CITY PLANNING COMMISSION

2. Tentative Map (P83-229)

Southwest corner of Dubois Avenue and Eaton Court

APPLC. NO. <u>P83-229</u>

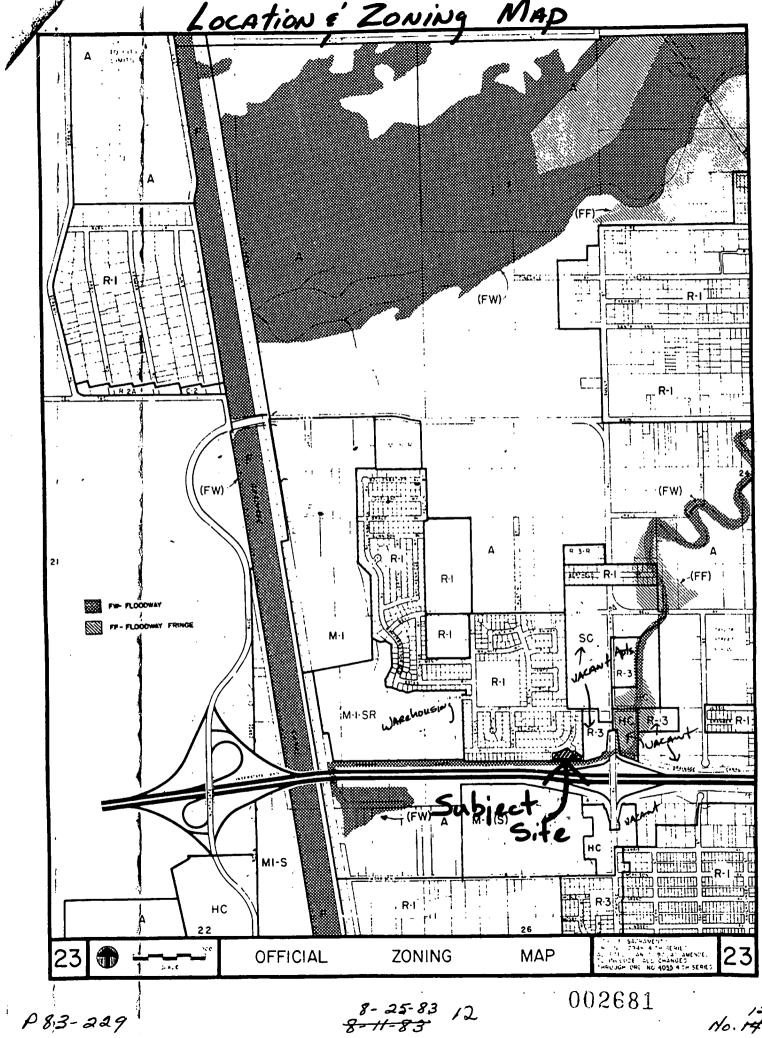
- 1. The subject site consists of two parcels created as a result of the construction of the I-880 Freeway. The applicant's proposal is a logical extension of the surrounding single family subdivision. The site is also zoned and designated for single family development. Staff has no objection to this request.
- 2. The Planning and Community Services Departments have determined that .1043 acres of land are required for Parkland Dedication purposes and that fees are to be charged in lieu of the required dedication. The applicant shall submit an appraisal of the land to be subdivided. The appraisal shall be dated and submitted not more than 90 days prior to the filing of the final map.

- a. Provide street lights, sewer and water services pursuant to Section 40.811 of the City Code; will require key cutting of curb and one-inch overlay of street surface;

- b. Pursuant to City Code Section 40.1302 (Parkland Dedication), the applicant shall submit to the City an appraisal of the property to be subdivided and pay the required parkland dedication in-lieu fees. The appraisal shall be dated not more than 90 days prior to the filing of a final map;

- c. Provide an accoustical consultant report which evaluates noise impacts and provides for sound attenuation measures necessary to achieve compliance with City and State noise standards for the review and approval of the City-County Health Department;

- d. If a sound barrier is required, the material and design of the wall shall be reviewed and approved by the Planning Director and shall be installed prior to the filing of the map.
